Product Change Notice (PCN)

Subject: Change of Lead Frame for Renesas Serial EEPROM SOP: R1EX24256BSAS0I#U0

Publication Date: 9/5/2023

Fig.1: Inner lead pattern (Before change)

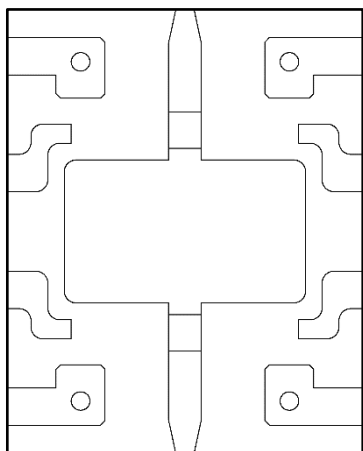
Regarding a select SOP product of serial EEPROM: R1EX24256BSAS0I#U0, the lead frame design is changed as shown in the following, but the lead frame material remains copper (Cu).
